Project	<b>IEEE 802.16 Broadband Wireless Access Working Group</b> < <a href="http://ieee802.org/16">http://ieee802.org/16</a> >	
Title	<b>Compression of Neighbor BS ID using MOB-NBR-ADV message</b>	
Date Submitted	<b>2004-08-29</b>	
Source(s)	<p>Taesoo Kwon, Dong-Ho Cho, Ki-Ho Lee, Howon Lee, Sik Choi, Juyeop Kim KAIST Div. of EE, Dept of EECS, KAIST, Yuseong-gu, Daejeon, Korea</p> <p>Sangboh Yun, Sunghyun Cho, Won-Hyoung Park, Yungsoo Kim Samsung AIT</p> <p>Yong Chang, Geunhwi Lim, Hong Sung Chang, JungWon Kim, TaeWon Kim Samsung Electronics Co. Ltd.</p>	<p>Voice: +82-42-869-3467 Fax: +82-42-867-0550 <a href="mailto:tskwon80@comis.kaist.ac.kr">tskwon80@comis.kaist.ac.kr</a></p> <p>Voice: +82-31-280-8196 Fax: +82-31-280-9555 <a href="mailto:sbyun@samsung.com">sbyun@samsung.com</a></p> <p><a href="mailto:yongchang@samsung.com">yongchang@samsung.com</a></p>
Re:	This contribution is response to call for contribution about IEEE 802.16e-D4

# Compression of Neighbor BS ID using MOB-NBR-ADV message

Fig 1 An example of the compression of neighbor B IDs using MOB-NBR-ADV message

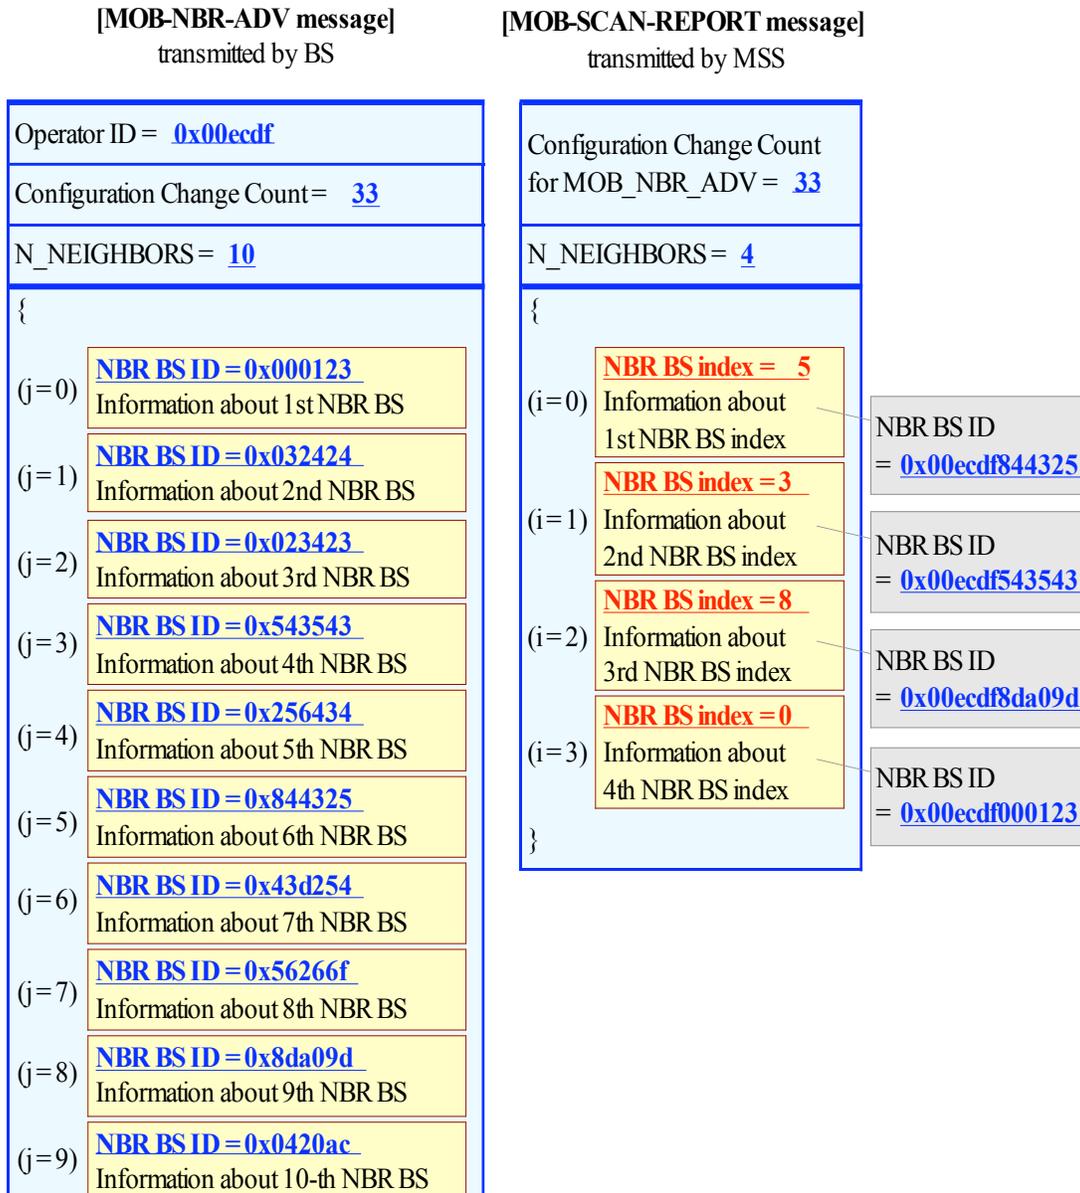
So, this contribution suggests the method to reduce the length of the neighbor BS ID when all neighbor BSs in the MOB-SCAN-REPORT message are members of the list of neighbor BSs in MOB-NBR-ADV message which the MSS receives within the some interval (NBR\_BS\_Index\_Validity\_Time). In this case, 8-bit “neighbor BS index” can be used instead of 48-bit MAC address of the BS, as neighbor BS ID. Here, “neighbor BS index” means the position in the list of neighbor BSs in MOB-NBR-ADV message, which is the same as loop index,  $j$ , of “For” statement of MOB-NBR-ADV message format in Table 106d. However, the MOB-SCAN-REPORT message has to include the value of “Configuration Change Count” of the referring MOB-NBR-ADV message in order to use neighbor BS index instead of MAC address of the BS, because the MOB-NBR-ADV message is broadcasted at a periodic interval (MOB-NBR-ADV interval). However, the MSS should decide whether it applies the compression of neighbor BS ID, using the timer of which the duration is NBR\_BS\_Index\_Validity\_Time, because this neighbor BS ID compression method may not be applied in case that it may not receive a number of MOB-NBR-ADV messages for some time due to the bad channel environment. If the compression cannot be applied, the conventional method is applied and so the corresponding messages such as MOB-SCAN-REPORT and MOB-MSSHO-REQ should indicate whether the compression of neighbor BS ID is applied or not, through the indication bit (Comp\_NBR\_BS\_ID\_IND). As stated in 6. 3. 20 MAC layer HO procedures, page 68 ~ page 82, handover operations may generally be assisted by MOB-NBR-ADV messages and so this compression method can effectively be used.

To support this compression method of neighbor BS ID using MOB-NBR-ADV, the BS has to keep mapping-table of neighbor BS MAC addresses and neighbor BS indexes transmitted through MOB-NBR-ADV message, for each Configuration Change Count. However, MSS can calculate the difference of MOB\_SCAN\_REPORT message transmitting time and MOB\_NBR\_ADV message receiving time, from Frame number of DL-MAP PHY Synchronization Field (Section 8.4.5.1 in IEEE P802.16-REVd/D5), and use neighbor BS index if this difference time is smaller than NBR\_BS\_Index\_Validity\_Time. Here, NBR\_BS\_Index\_Validity\_Time should

Fig 1 shows an example to illustrate the method of neighbor BS ID compression using MOB-NBR-ADV message.
